DATA REQUEST RESPONSE
Bear Valley Electric Service, Inc.
Wildfire Mitigation Plan

Response provided by: Paul Marconi
Title: President, Treasurer & Secretary
Data Request Number: CalAdvocates-BVES-2021WMP-02
Date Received: March 26, 2021
Date Due: April 2, 2021
Date Provided: April 2, 2021

From Alan Wehrman (California Public Advocates Office) email to BVES dated March 26, 2021. The following questions relate to BVES's Wildfire Mitigation Plan 2021.

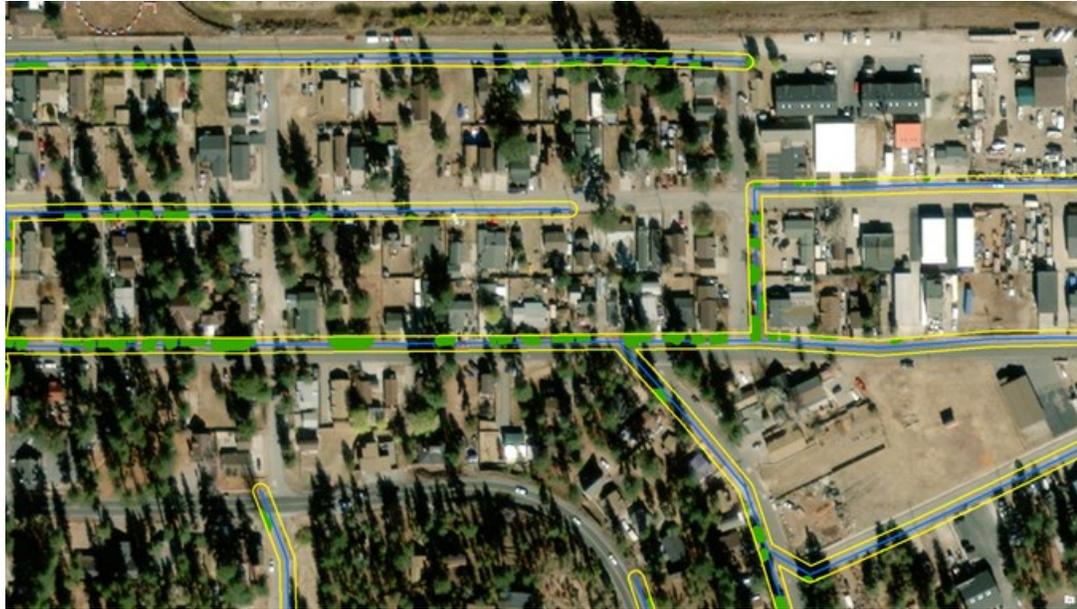
2. **On p.22, Supporting Table 4.2-1 includes columns for “Vegetation Density” and “Wind Intensity.”**
- a. **What are BVES’s criteria for high, medium, and low Vegetation Density?**
 - b. **What are BVES’s criteria for high, medium, and low Wind Intensity?**
 - c. **How were the criteria described in parts (a) and (b) developed?**

Vegetation density is currently based on SME evaluation of the vegetation around the circuit. BVES is exploring several methods to establish vegetation density. The first method is to take the number of trees that are trimmed along a circuit and divide it by the number of spans. BVES is considering using the following criteria: Low Density is less than 2 trees per span; Medium Density is 2.1 – 4.9 trees per span. High Density is greater than 5 trees per span. Because our vegetation management contractor has placed most trees in the GIS, we will be able to be more quantitative in the coming year. Another promising method is to utilize LiDAR results as follows:

- Encroachment Zone Acres (yellow boundary) - when we apply a 12-ft distance on each side of the conductor, we create a zone in polygon format, meaning that we are looking at the area around the centerline. We use this to determine the entire extent in acres for the encroachment zone that trees could occupy.

- Tree Acres (green polygons representing trees) - these are the approximate acres of trees within the Encroachment Zone that are occupying space on either side of the conductors.

- Tree Percent - this is a standard formula for a percentage that we use to determine what percentage of the circuit is covered by trees (Tree Acres / Encroachment Acres * 100). This is one measure of density because it tells you how much vegetation is impacting the tree/wire interface.

- From the picture below, we summarize all tree canopy polygons within the yellow boundary and get an acreage total. Then, we divide that total by the acreage of the encroachment zone to get the percentage. As mentioned before, this is the quickest way to get a good estimation on which feeders have the most vegetation currently on them, which could signify a higher priority.
